Subject: Groundwater Compliance Action Plan (GCAP) for the Green River, Utah, Site

Preliminary Final Groundwater Compliance Action Plan for the Green River, Utah, Disposal Site

DOE Responses to State of Utah Comments

Comments to the draft preliminary final groundwater compliance action plan (GCAP) for the Green River, Utah, disposal site (September 2005) were received from the State of Utah in a letter dated August 14, 2006. Below are summary statements of the State's comments followed by U.S. Department of Energy (DOE) responses. The responses have been incorporated where appropriate into the current *Preliminary Final Groundwater Compliance Action Plan for the Green River, Utah (UMTRCA Title I), Disposal Site* (February 2008).

Figure 5. Monitoring Network and Institutional Controls Boundary at the Green River Site

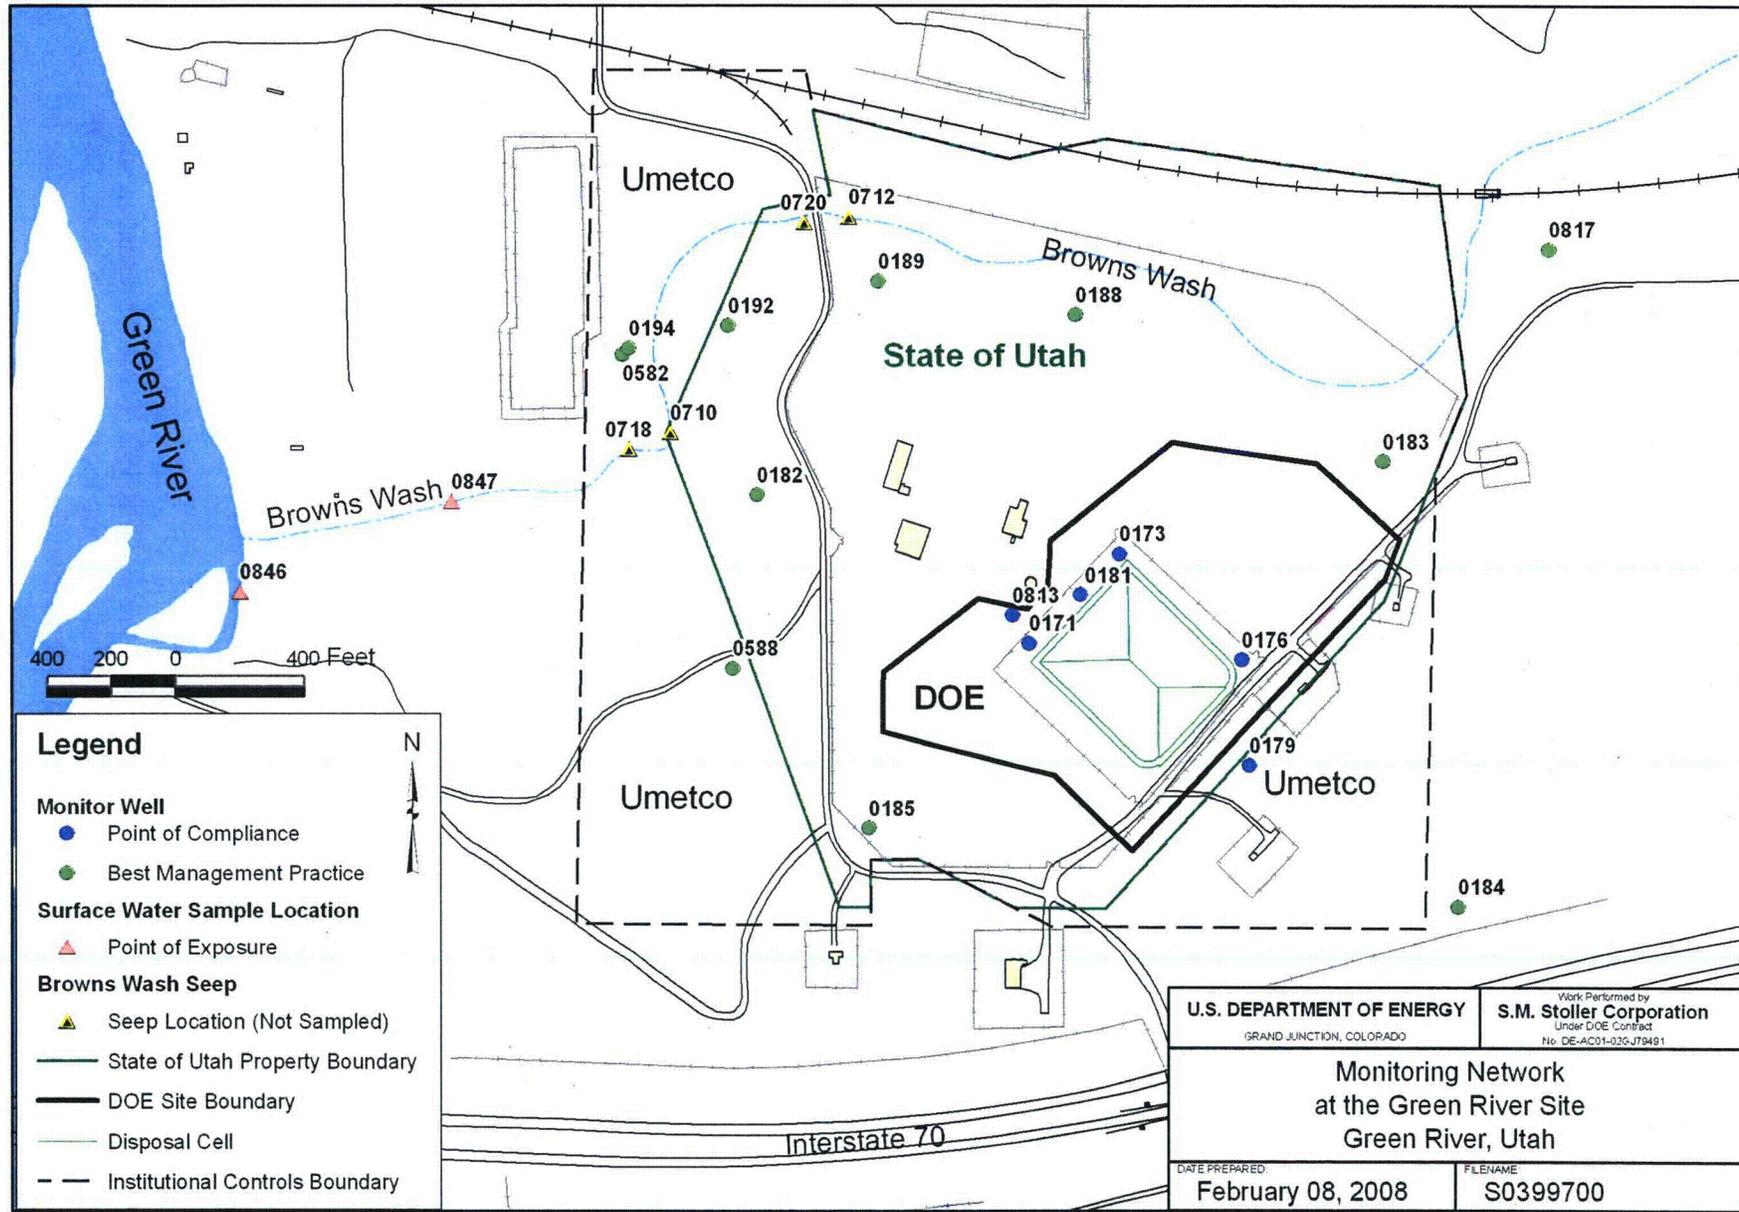
2. **State Comment:** Add Browns Wash alluvial wells as POC wells because of the potential that the contaminated groundwater from the middle sandstone unit of the Cedar Mountain Formation could discharge into the Browns Wash alluvium and because of historic elevated selenium and uranium in some of the wells.

1. **State Comment:** Apply surface water protective standards to the Green River and backwater surface water sampling locations because the middle sandstone unit crops out in Browns Wash.

DOE Response: The elevated contaminant concentrations in the alluvial monitor wells are the result of processing activities and are not from the disposal cell (unprotected mill tailings were stockpiled on the Browns Wash alluvial floodplain on the south side of the wash). DOE recommends application of supplemental standards for the Browns Wash alluvium because of its low yield and impracticability to treat the groundwater. Therefore, DOE does not recommend including the alluvial wells as POC wells.

It is expected that the contaminants in the Browns Wash alluvium will eventually move downgradient and mix with the Green River alluvium groundwater and the river water. DOE

intends to continue monitoring selected alluvial wells (MW-0188, 0189, 0192, and 0194) as a best management practice to observe this expected trend.

DOE Response: DOE agrees to apply surface water standards to the two surface water sampling locations as addressed above. For clarification, the middle sandstone unit does not crop out in Browns Wash. The lenses of rock that crop out in Browns Wash represent the complexly interbedded upper unit of the Cedar Mountain Formation.
